Council Assessment Report

SNPP No	2018SNH063
DA Number	MOD2018/268
Local Government Area	City of Ryde
Proposed Development	Modification to LDA 2015/0654 pursuant to S.4.55(2) to modify Building D to create private roof terraces for apartments D501 to D504 including construction of separate staircases enclosure, balustrade and privacy screens.
Street Address	723-731 Victoria Road, 10 Little Church Street & 3-7 St Annes Street, Ryde.
Applicant/owner	CD Architects/Kaloriziko P/L
Date of Lodgement	9 November 2018
Number of Submissions	One
Recommendation	Refusal
Regional Development Criteria (Schedule 7 of the SEPP (State and Regional Development) 2011	Original Consent determined by the then Sydney East Joint Regional Planning Panel as the Capital Investment Value Exceeded \$20M.
List of All Relevant s4.15(1)(a) Matters	<ul style="list-style-type: none"> • Environmental Planning and Assessment Act 1979; • State Environmental Planning Policy No 65 – Design Quality of Residential Apartment Development; • Ryde Local Environmental Plan 2014; and • City of Ryde Development Control Plan 2014.

Figure 7: Plan view of roof area of Building B with the area to be used as private open space outlined in blue.

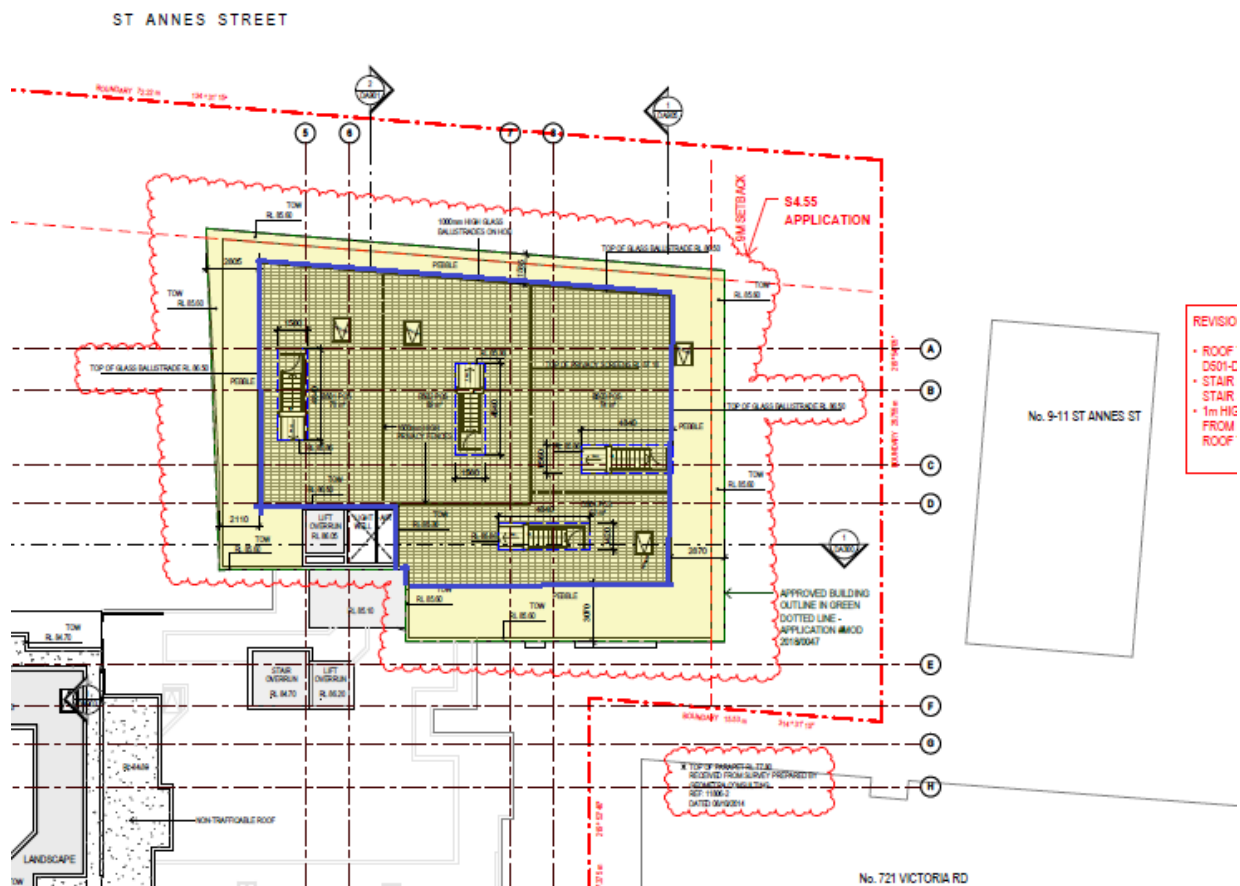
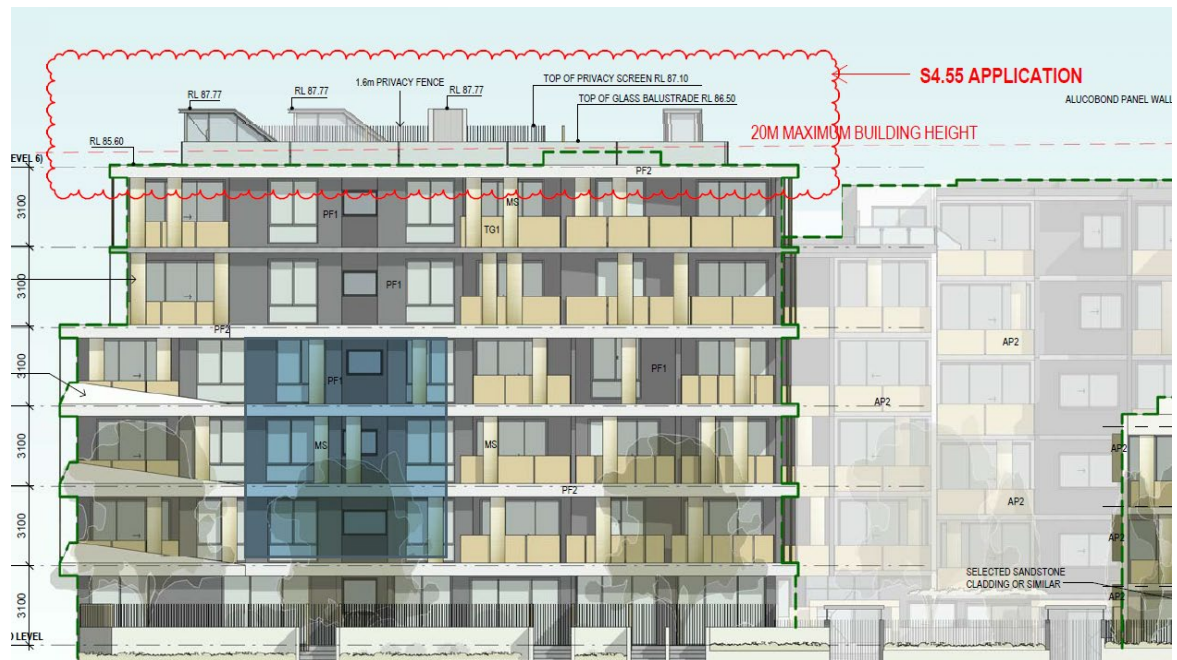
Modifications are now sought to change the roof area of Building D to provide four private rooftop courtyards for apartments D501, D502, D503 & D504.

Access to the roof top courtyards will be from an internal staircase to a metal and glass framed enclosure above.

It is also proposed to provide 1.6m high privacy screens between each of the private courtyards and a 1m high glass balustrade setback from the edge of the roof to the perimeter of the courtyards, as illustrated in **Figures 6 & 7** below.

"The proposed roof top terrace area will be accessed by stairs from each of the four apartments benefiting from the space. The use of the rooftop area will necessitate material changes to the building to accommodate four separate stair overruns and a perimeter balustrade.

Cumulatively, the changes have the appearance of an additional storey, which is at odds with the parent development consent, approved on the basis of having achieved a reduction in the building height from what had initially been proposed. Because the proposed rooftop terrace is to be shared between four apartments, each apartment has its own separate covered stair access to the rooftop, which further exacerbates the visual bulk and silhouette of the building.

This proposal is for four private courtyards with a 4.8m x 1.56m and height of 2.1m stairwell enclosure each, 1.6m high privacy fences around each of the courtyards and perimeter fencing all above the 20m height control. No shading structures are shown to be provided however it is reasonable to assume that shade structures will be erected for each of the courtyards. Therefore the cumulative effect of the four private courtyards and their ancillary structures will have the appearance of an extra storey, resulting in a 7 storey building. This is not in keeping with the character of nearby developments. Within the subject site the other three buildings are 3 to 6 storeys with adjacent properties - 721 Victoria Road being part 4/part 5 storeys and 9-11 St Annes Street 3 storeys.

The applicant has argued that *“the four stair wells providing access to the rooftop terraces in plan view equated to 0.7% of the entire roof area, which is a very minor portion of the roof.”* This is not supported by Council, as when viewed from St Anne Church, the eastern elevation will have a total length of 17.2m of area (this includes the outer glass balustrade around the perimeter of the courtyards) above the 20m height control, equating to 78% of the eastern elevation and appearance of an additional storey.

Consideration may be given to the use of the rooftop terrace as communal open space, accessed via a singular entry point and having a reduced floor area to ensure that the balustrade is not visible from Little Church Street or at any view point within the St Anne's Church site. It would be reasonably

Figure 8: Line of vision from the courtyard area to the adjoining south western property – 721 Victoria Road.

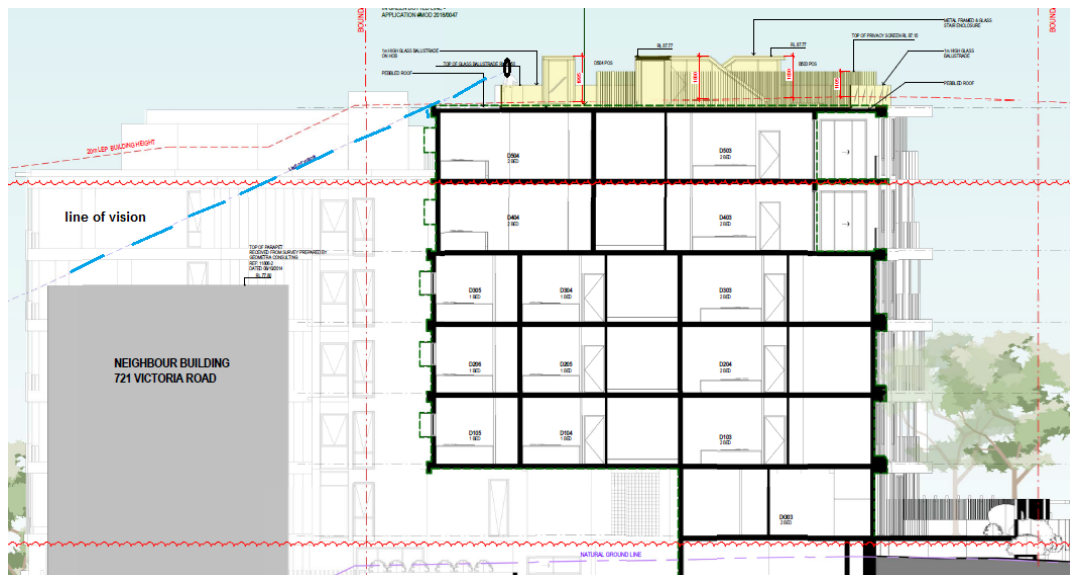
Comments	Comply															
	<p>Victoria's Road rear windows is not an issue, as illustrated in Figure 8 below.</p> <p>The separation between the proposed courtyards and the adjoining property to the east (9-11 St Annes Street) is 15m. 9-11 St Annes Street is a 3 storey residential flat building. The adjoining building is significantly lower and due to the separation, over looking into St Annes' side windows will be minimal.</p>																
<p>4E Private Open Space and balconies Apartments must provide appropriately sized private open space and balconies to enhance residential amenity.</p> <p>Design criteria 1.All apartments are required to have primary balconies as follows:</p>

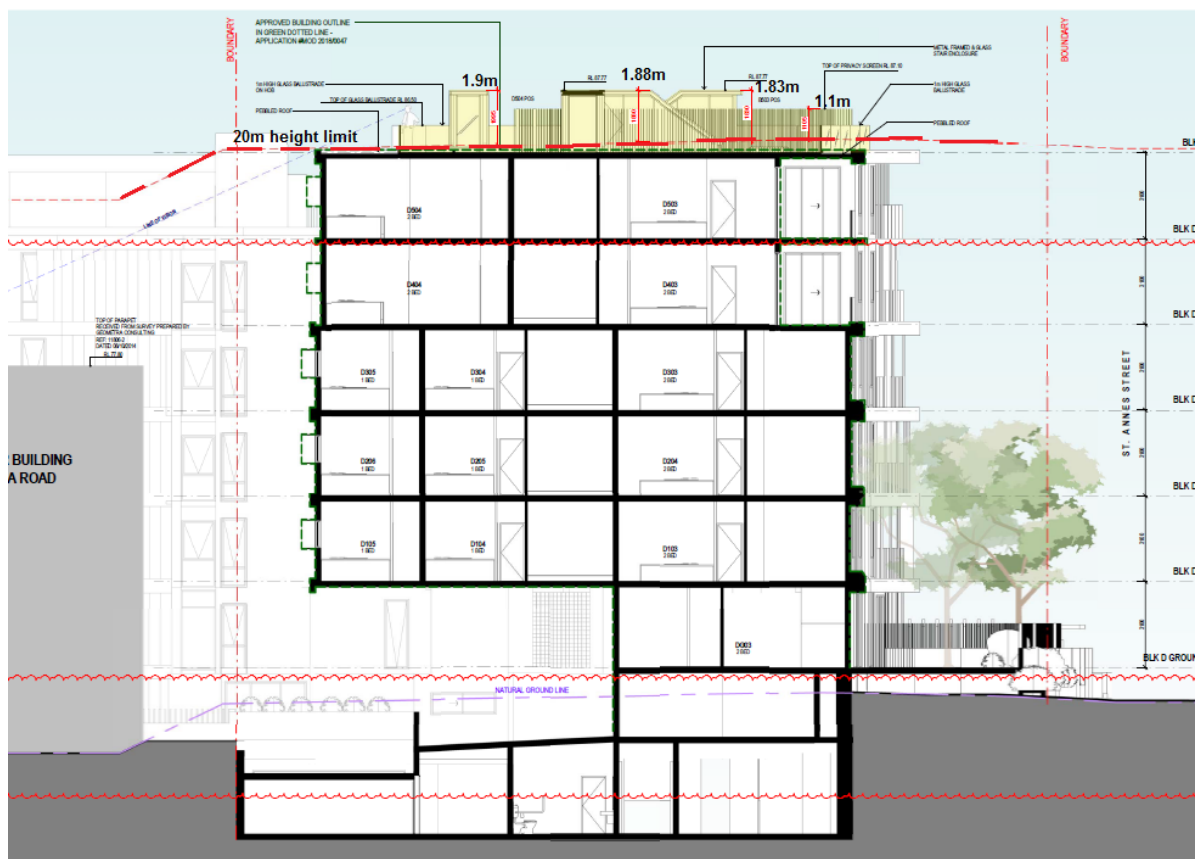
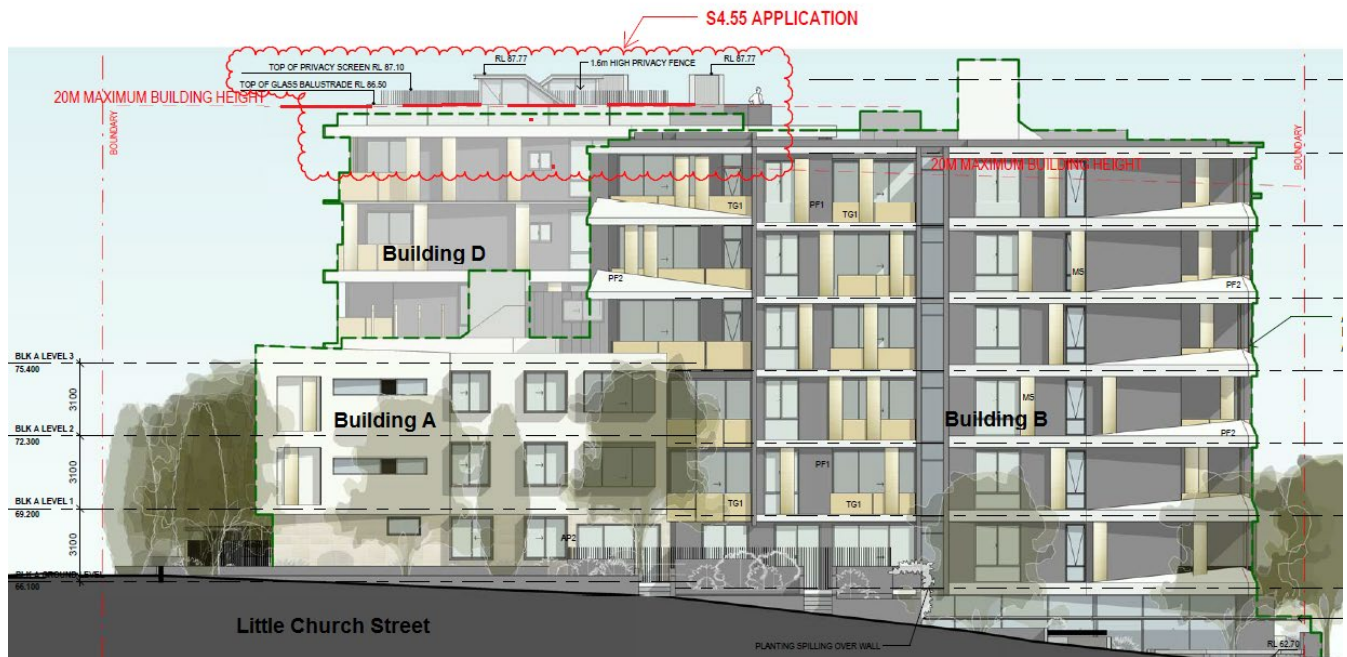
The proposed modification to provide 4 x private courtyards on the roof top of Building D will result in a height non compliance to Building D by 1.1m to 1.98m a variation of between 5.25 to 9.9%, as detailed in **Figures 10 & 11** below.

Council supported the original Clause 4.6 variation to allow for the variation to Building B for the reasons stated above. However in this instance, the proposed variation to Building D is not supported.

Accordingly, the proposed variation in height will have an adverse visual impact on the adjacent heritage item.

In addition, the proposal for four individual stairwells and privacy fencing all above the height control will set an undesirable precedent which will undermine the objectives of the height control. Accordingly the proposed modifications cannot be supported by Council.
